Re: **Response to Peer Review Comments Regarding Site Plan Review Application
Proposed 5.49 MW DC Solar Electric Generating Facility, Dual-Use and Agriculture Use
43 & 53 Pleasant Street, Southampton, MA 01073**

Peer review comments from the BDG letter dated September 11, 2026 are itemized below in regular font, with Weston & Sampson's responses provided immediately following each comment in *italic* font.

5.49 MW (DC) AGRIVOLTAIC SOLAR DEVELOPMENT & BATTERY ENERGY STORAGE SYSTEM (BESS) FACILITY

C102

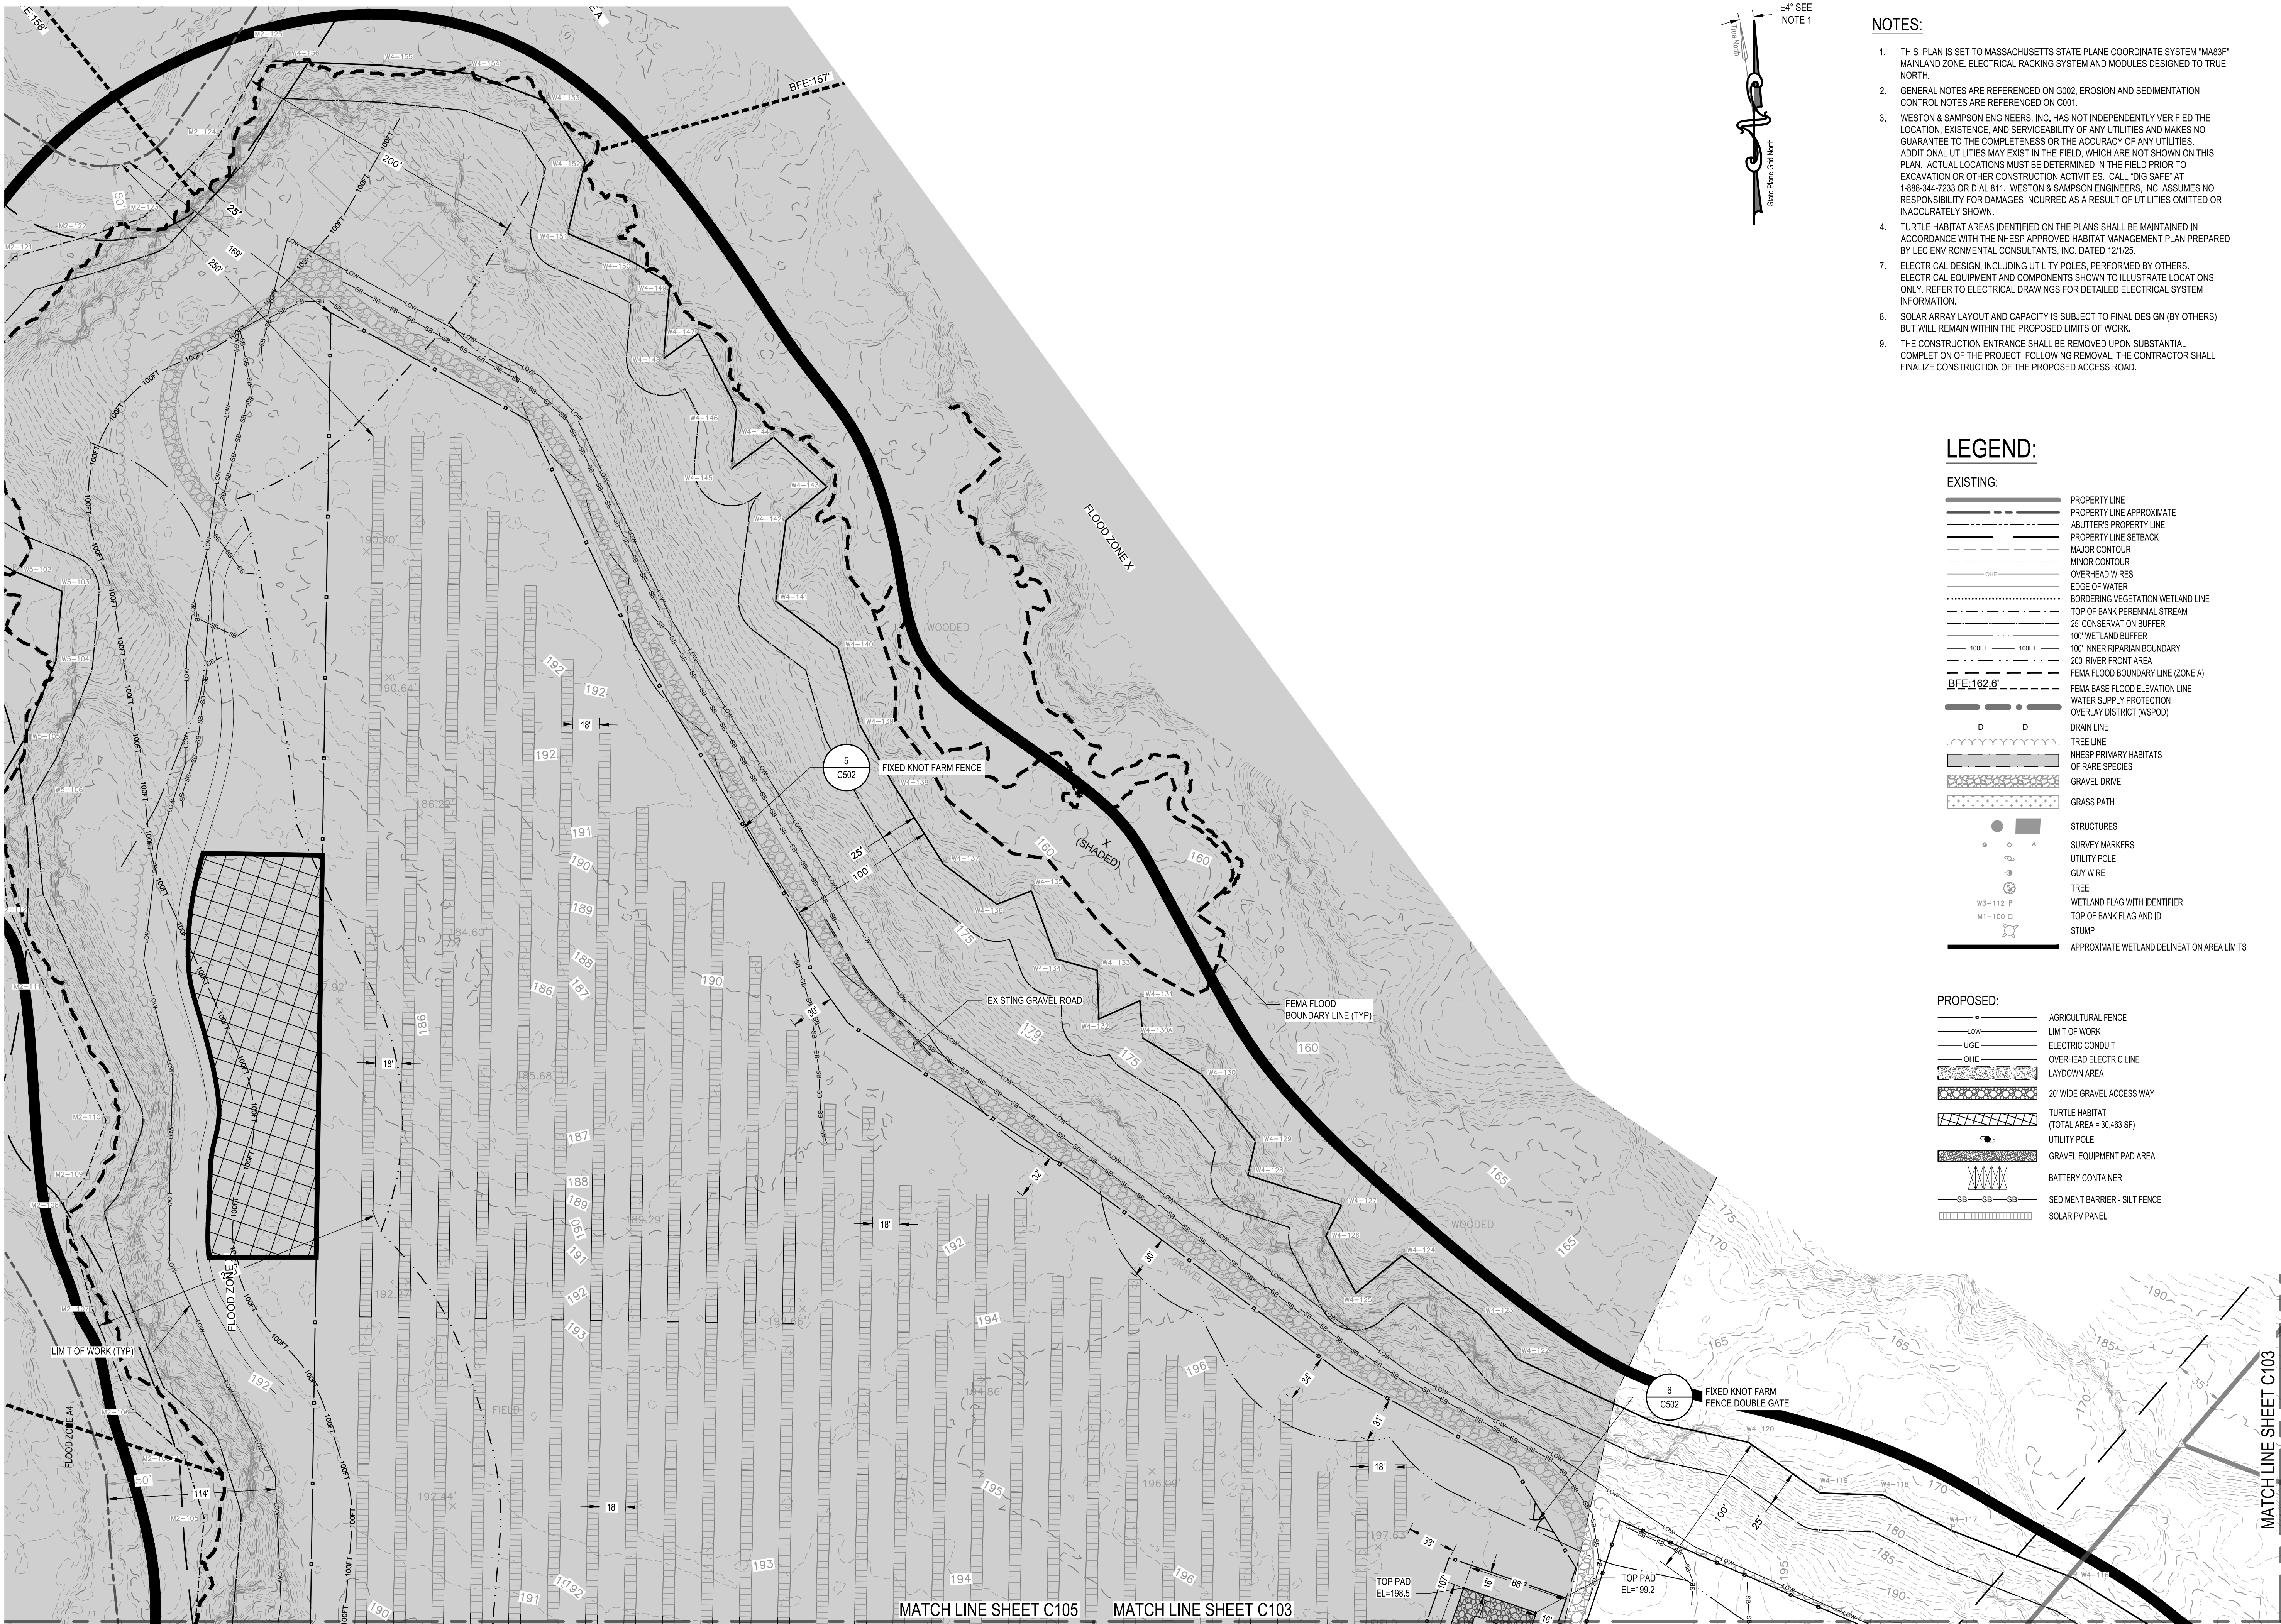
- 10) § 275-7.6G(9)(b)[1] provides that solar electric generating facilities shall be designed and constructed so that no installation occurs on slopes greater than 15 percent. The Stormwater Report states that site slopes range from approximately 2 to 8 percent, with limited areas up to 26 percent. The Project Description states that the project meets this requirement. The applicant should provide an exhibit identifying areas of the site exceeding 15 percent and demonstrating compliance.

- 19) The zoning conformance narrative does not address § 275-7.1, the Floodplain Overlay District. The project appears to lie entirely outside the floodplain; however, the plan sheets carry a number of overlapping resource and jurisdictional lines, which makes the floodplain boundary difficult to read. The application also mixes flood map editions: the survey sheet cites preliminary panel 25015C0477E dated August 27, 2025, while the Stormwater Report uses the effective (older) designations. § 275-7.1B bases the extent of the district on the “most recent Flood Insurance Rate Map”. The Board’s review would benefit from a simplified figure for the record clearly showing only the Floodplain Overlay District boundary, the limit of the effective floodplain and the limit of work.

Response: Hatching has been added to Sheet C102 showing locations on site where slopes exceed 15% to demonstrate compliance with bylaw.

Response: The Floodplain Boundary Line and Limit of Work Line are now shown in color on sheet C102 for clarity.

8 CONCRETE EQUIPMENT PAD SECTION (TYP)

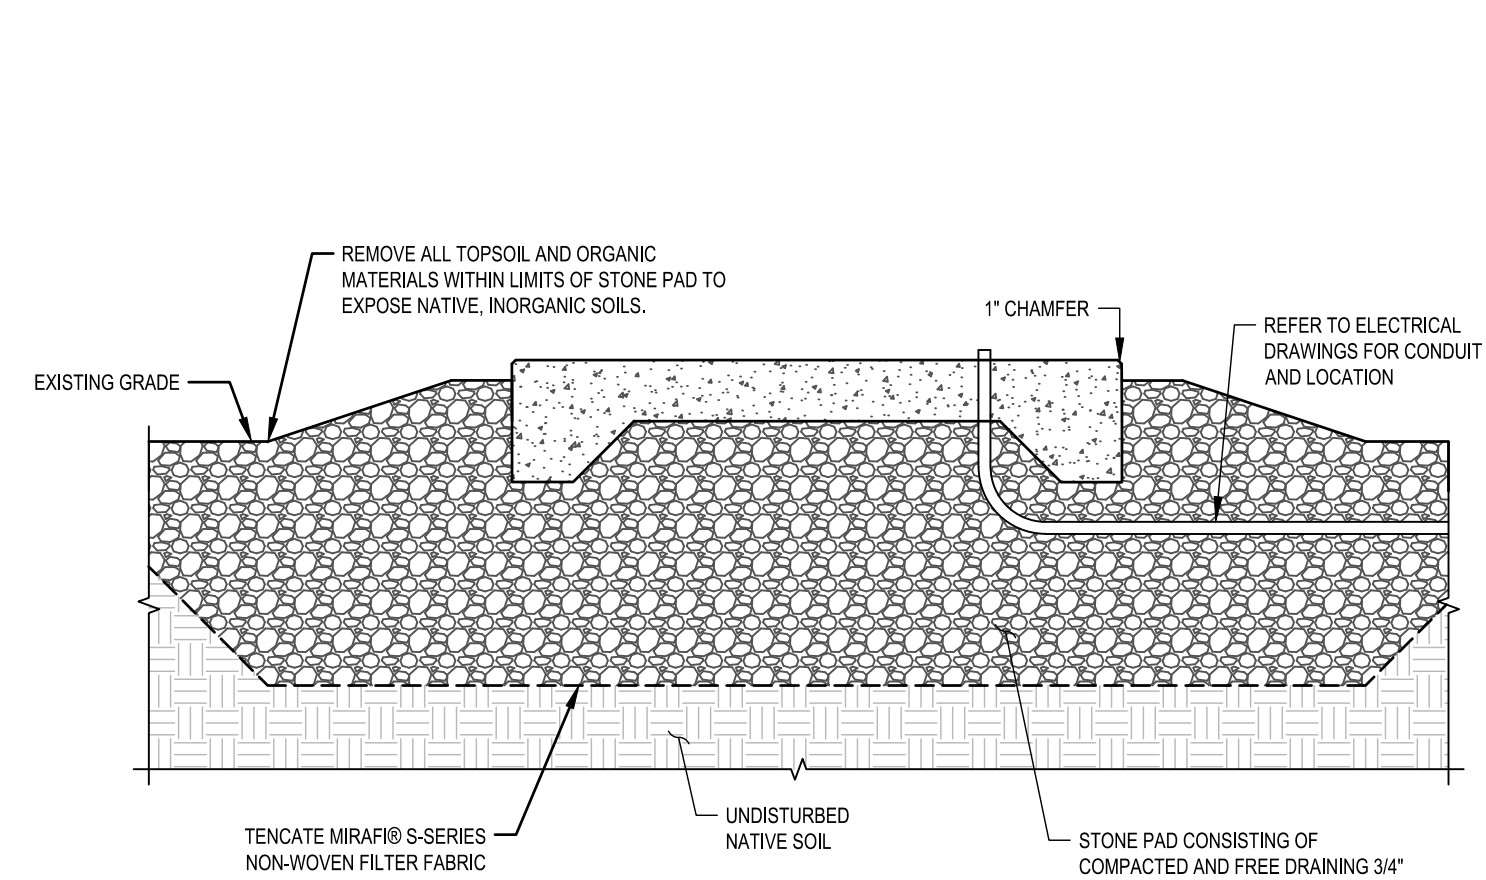
- 5) At each equipment pad, the plans show an unimproved sixteen-foot space inside the perimeter fence between the fence and the gravel pad area. Pad #2 also shows an unimproved gap between the twenty-foot access way and the fence. The applicant should confirm whether hardened access road surfacing will connect to the gravel equipment pad.

Response: The access road has been extended to connect with both gravel equipment pad areas.
